TECHNICAL BULLETIN	
	December 2000 TB 1849
Mfg:	FORD
Model:	F-SERIES
Liter:	7.3L
V I N:	F
Year:	95-05

Sudden Loss of Oil Pressure On
1996-97 Ford 7.3L VIN F Engines

Bulletin Diagram: FIGURE 1, DEAERATION VALVE - CYLINDER BLOCK

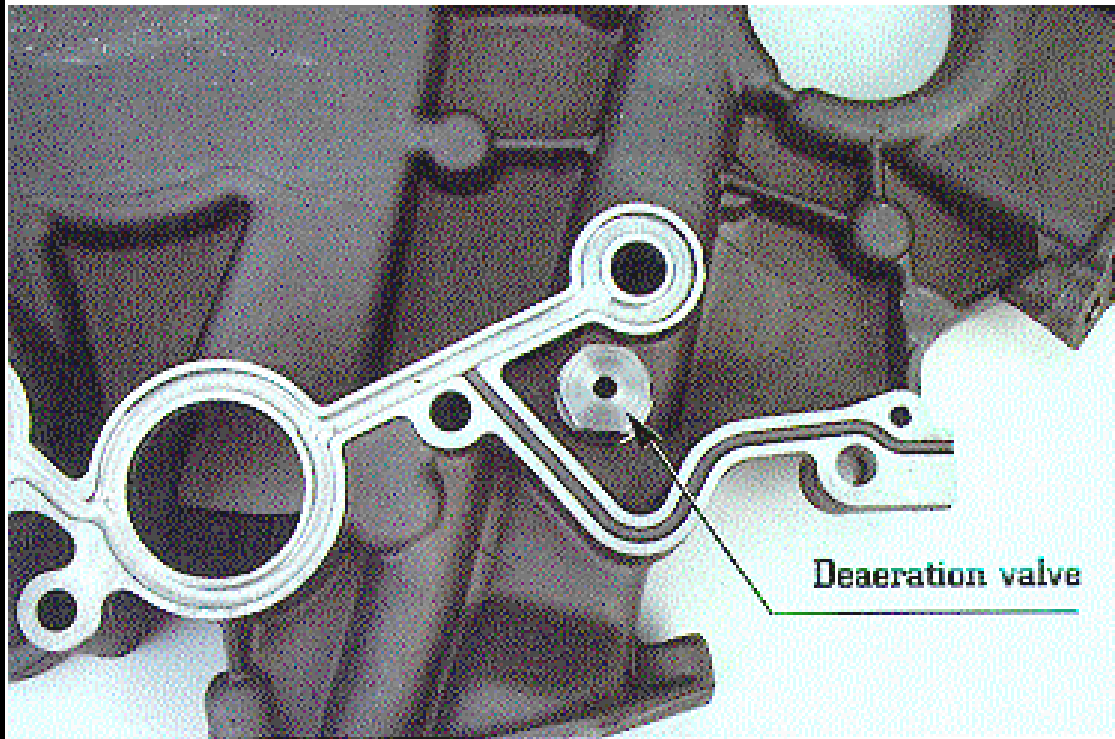
The cause of this engine oil pressure loss is resulting from the oil systems threaded de-aeration valve re-locating within its threaded opening. Depending on the movement and location of this valve, varying amounts of pressure loss have been reported. If the valve is completely dislodged, a $\frac{3}{4}$ " opening will exist in the pressure side of the oiling system. The valve may have loosened from extended engine cycles and normal engine vibrations. It is suggested to use Loctite® on the threads of this valve when re-installing. The valve is located within the front cover of the engine as shown below in Figure 1.

Engines built beginning with serial #201681 through 375549 used this de-aeration valve. Engines built beginning with serial #375550 were redesigned and did not incorporate the de-aeration valve.

Bulletin Diagram: FIGURE 2, INLET PORT RELOCATION - CYLINDER BLOCK

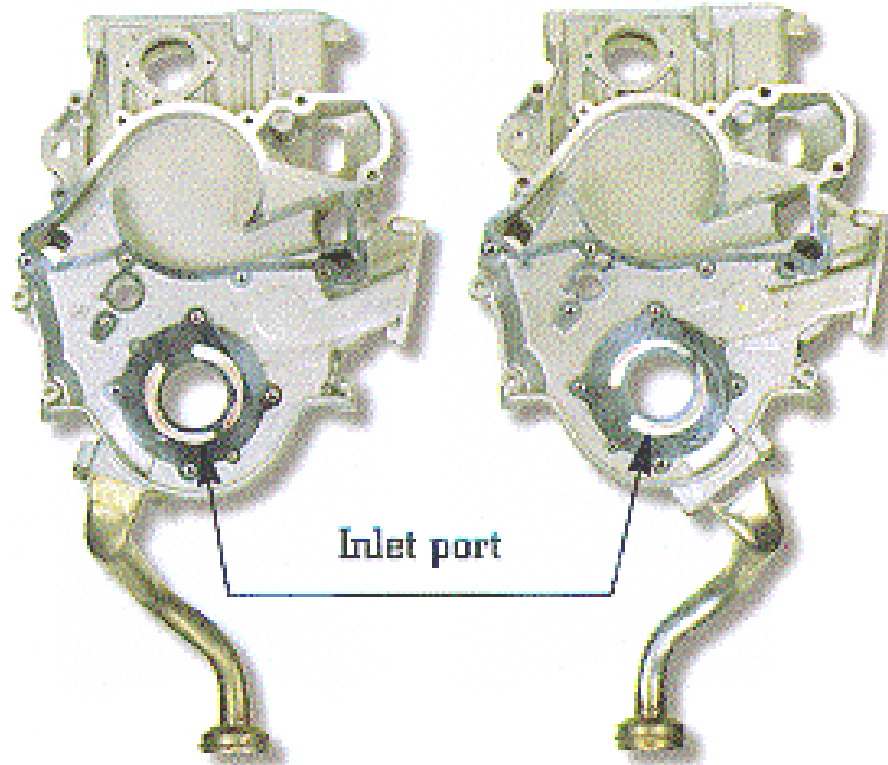
The front cover was also redesigned with serial #375550 to help keep the oil pump primed for initial start up. To accommodate this change, the oil pump inlet port was rotated approximately 90° which also moved the pick up tube from the engine's left side to the engine's right side as shown below in Figure 2.
